HOLLISTER DOMESTIC 30684 OWNER / LANDLORD RESPONSIBILITY SCHEDULE	OWNER FURNISHED	OWNER INSTALLED	LANDLORD FURNISHED	LANDLORD INSTALLED	N/A	COMMENTS
	PLEASE NOTE: IF ITEM IS NOT LISTED, IT IS GC RESPONSIBILITY FOR PROCUREMENT AND INSTALL PER THE CONSTRUCTION DOCUMENTS						
DIVISION 01 - GENERAL REQUIREMENTS

DEMOLITION & EXISTING CONDITIONS FLOOR PLAN

CONSTRUCTION PLAN

E8 HIDDEN DOOR

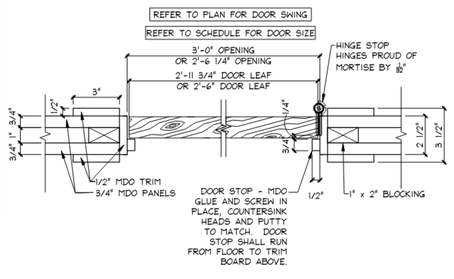
DETAILS NEEDED FROM AS-BUILTS. REFER TO A0.10 FOR RESPONSIBILITY OF WORK.

DEMOLITION & EXISTING CONDITIONS FLOOR PLAN

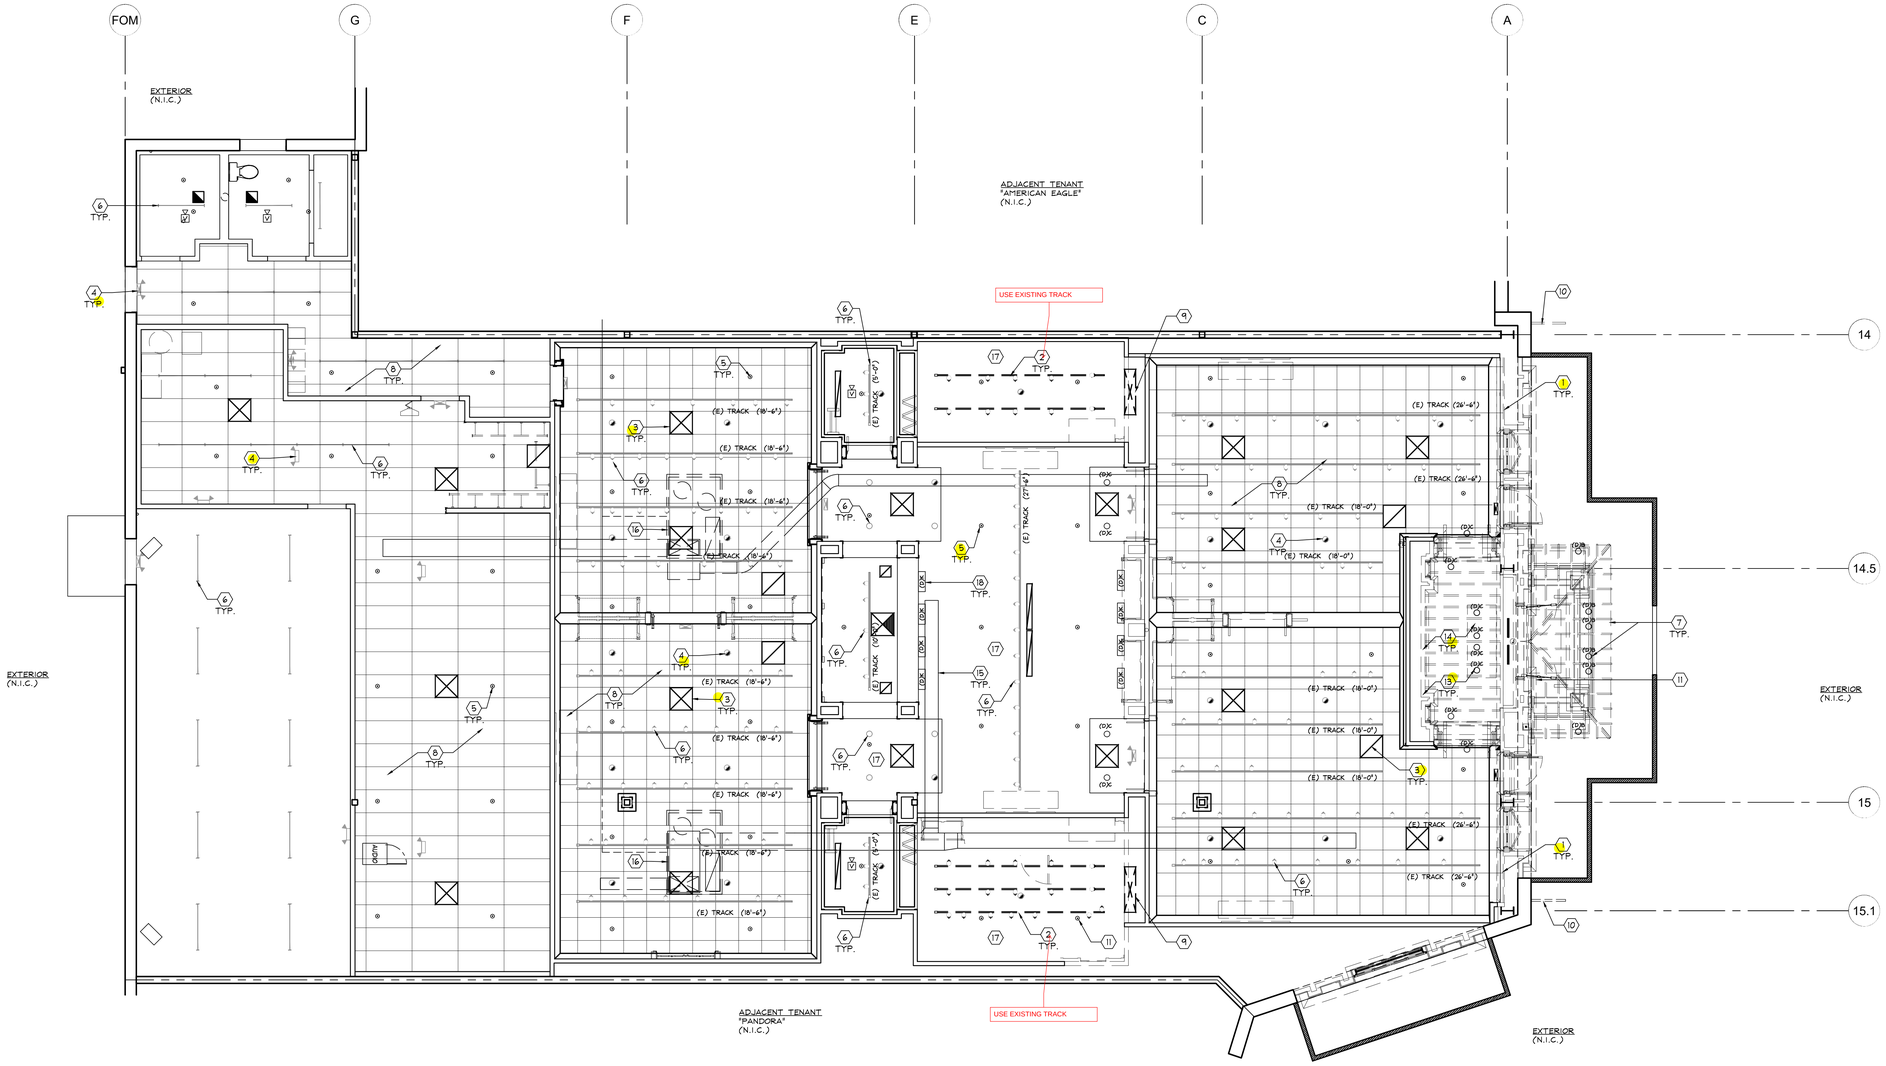
ADD NOTE TO SAVE AND PROTECT ALL HVAC CONTROLS/ PANELS AND CABLING FOR RE-USE.

BARRICADE ELEVATIONS

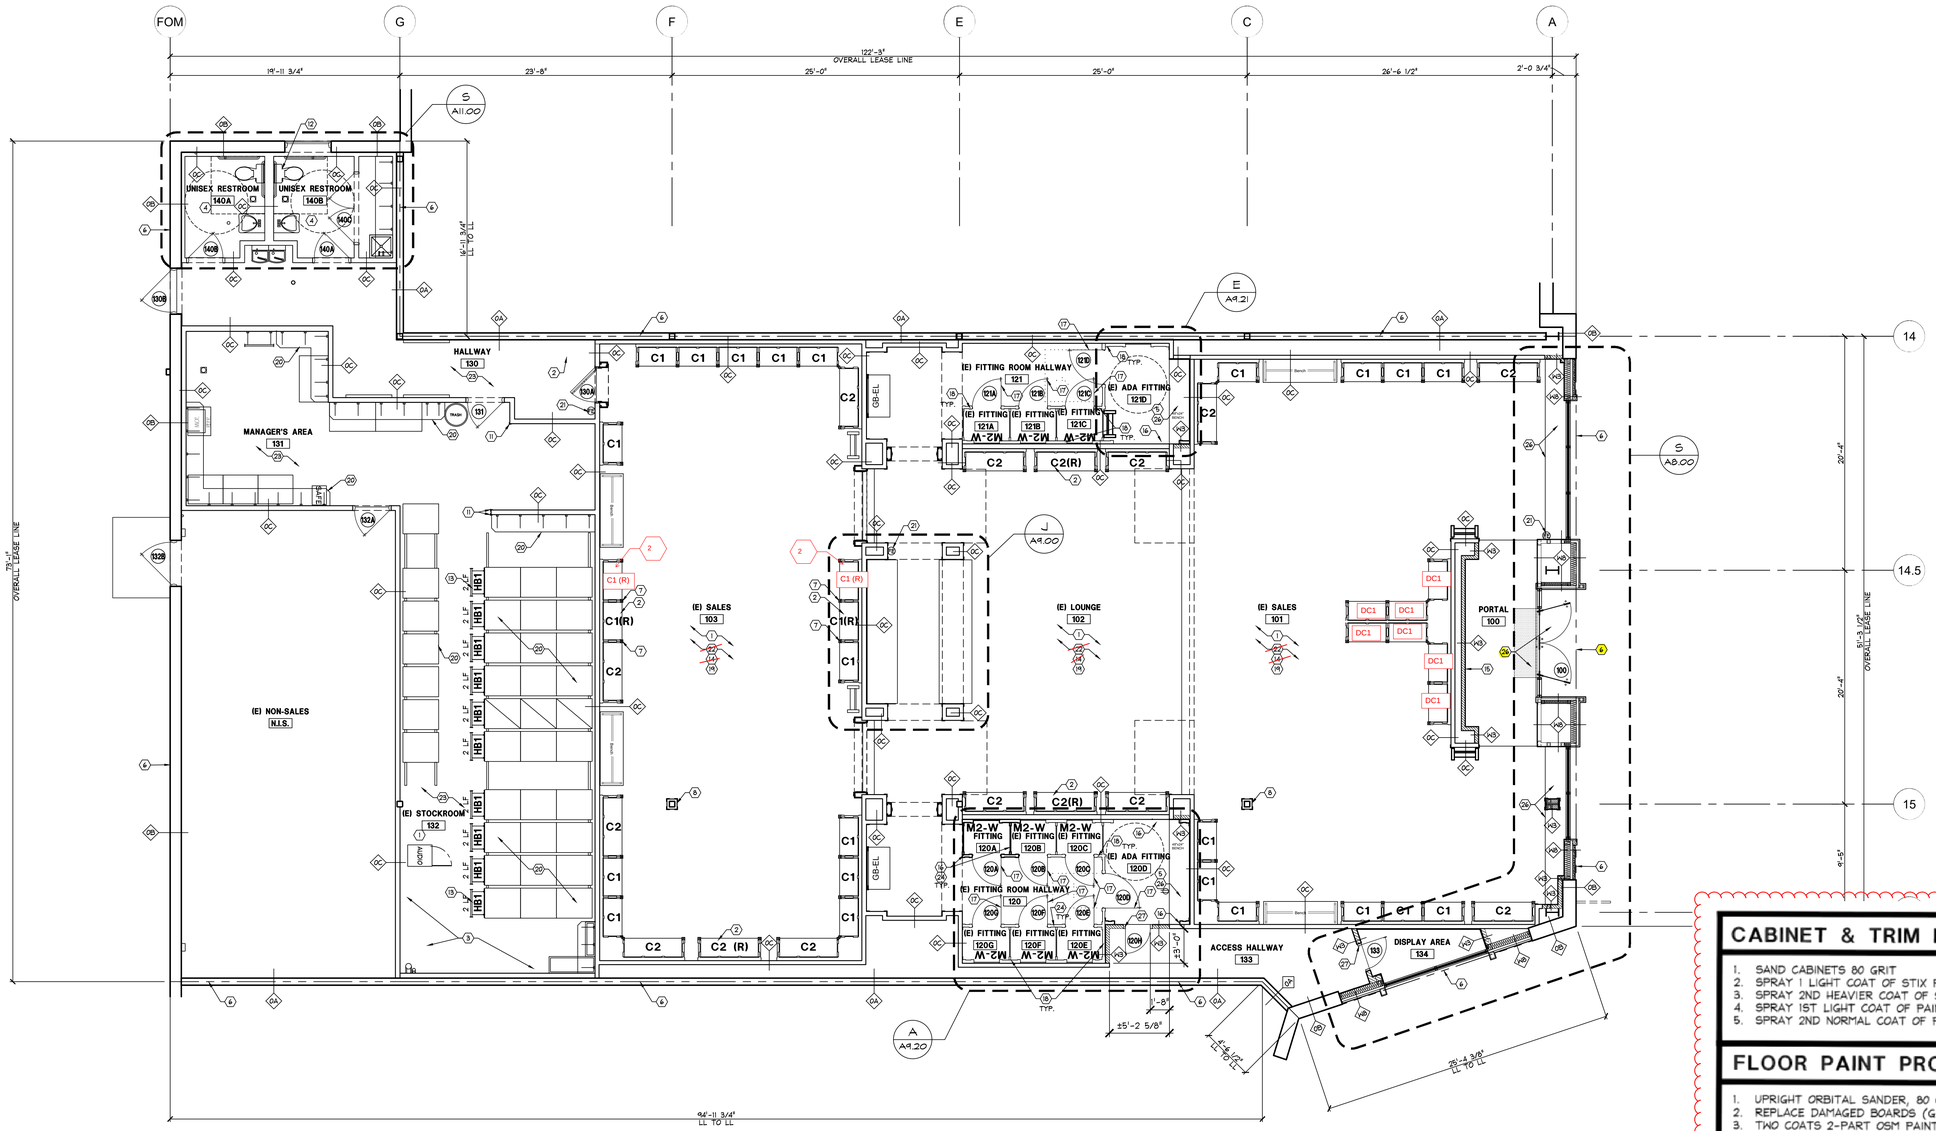
BOSTON BARRICADE IS BUILDING THE STOREFRONT PER RESPONSIBILITY SCHEDULE AND RON'S ESTIMATE. THIS SHEET CAN BE REMOVED.

CONSTRUCTION PLAN

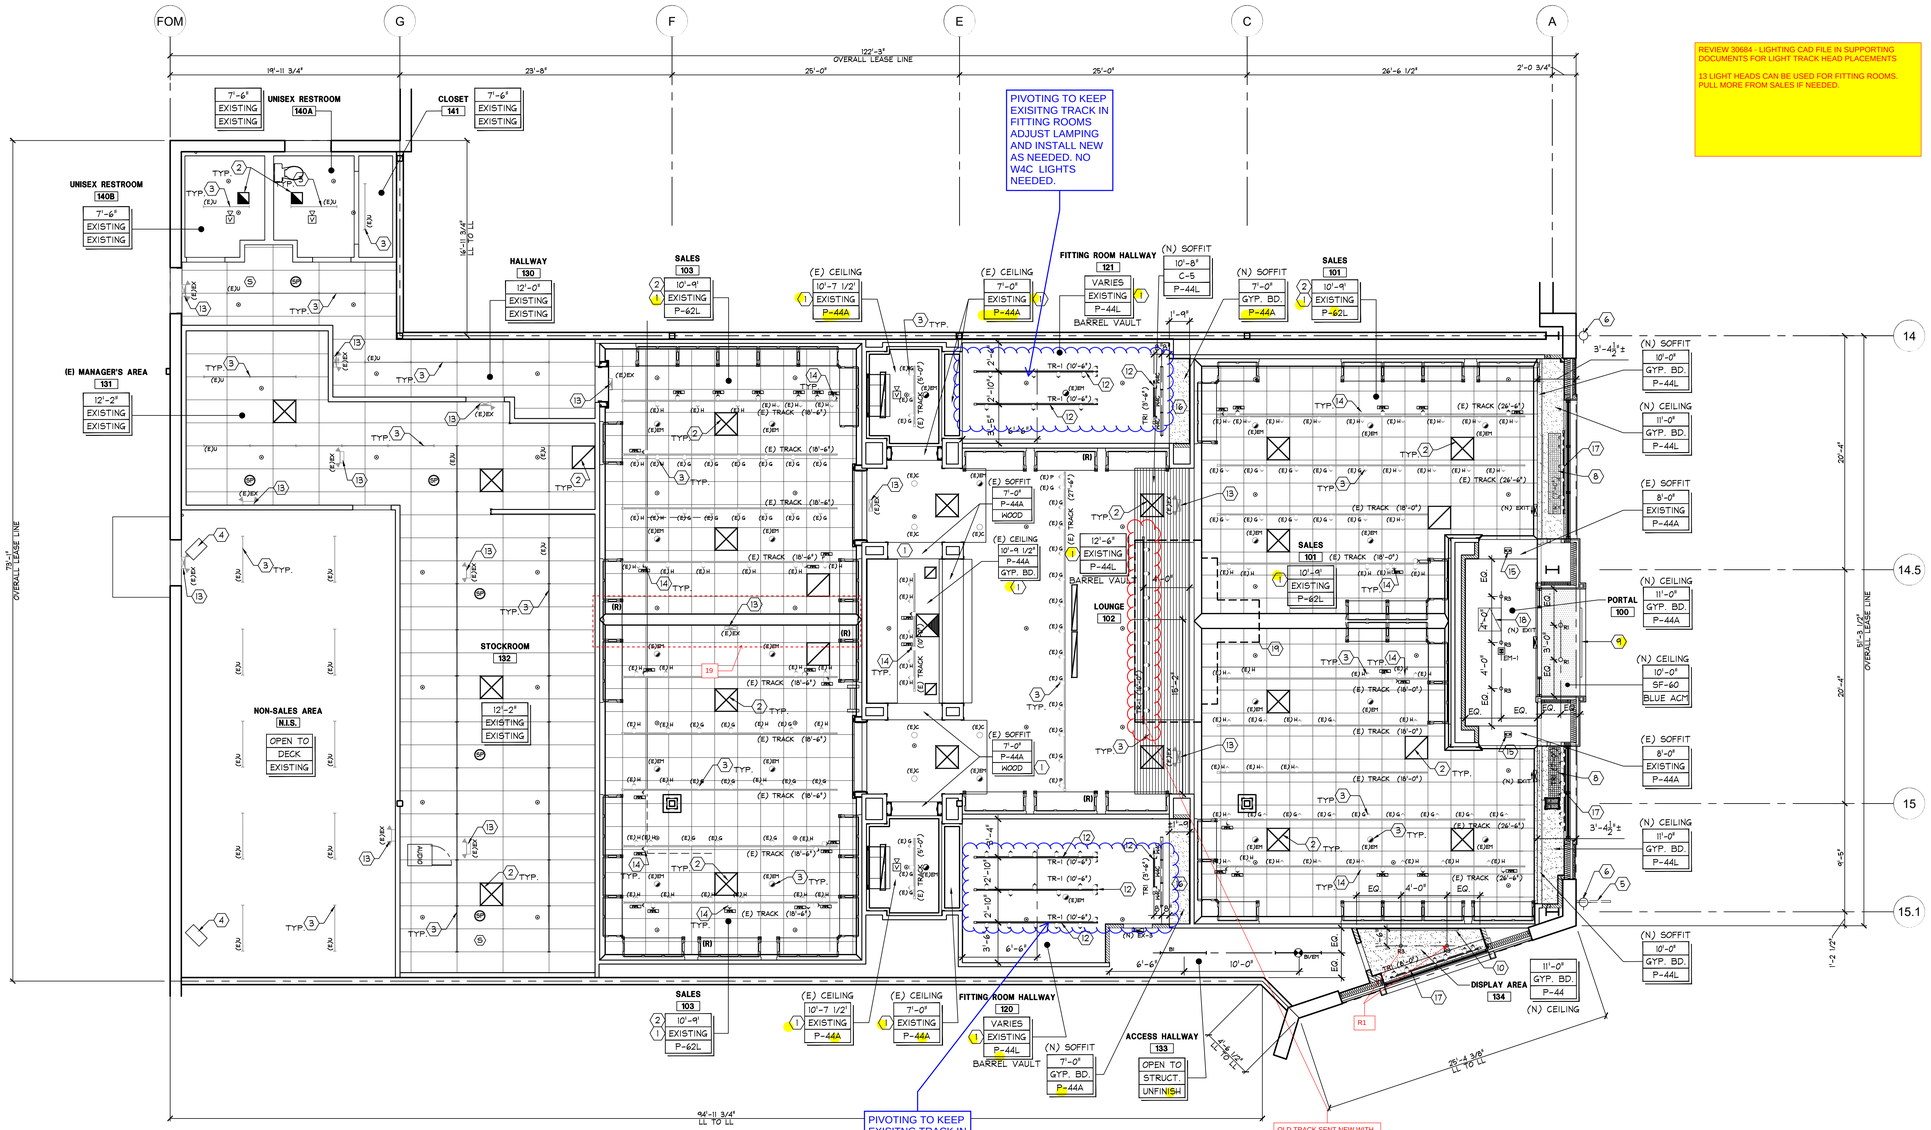
PULL FROM NEW HH REMODEL MASTER IN SUPPORTING DOCUMENTS FOLDER PROVIDED

S E4.00 **EAS - 3004 LOOP**
SCALE: NONE

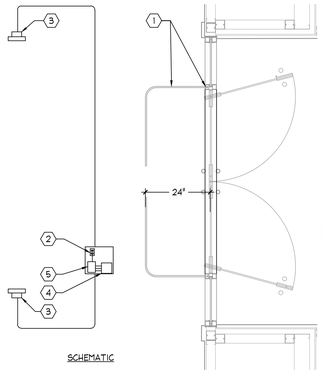
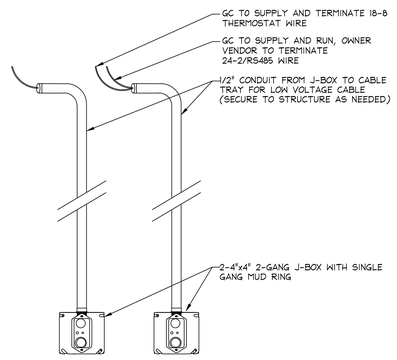
CODED NOTE 2 IS NOT CALLED OUT IN PLANS ABOVE. I BELIEVE THERE WAS A MISTAKE IN THE PLAN VIEW AND ITS SHOWN A "1".
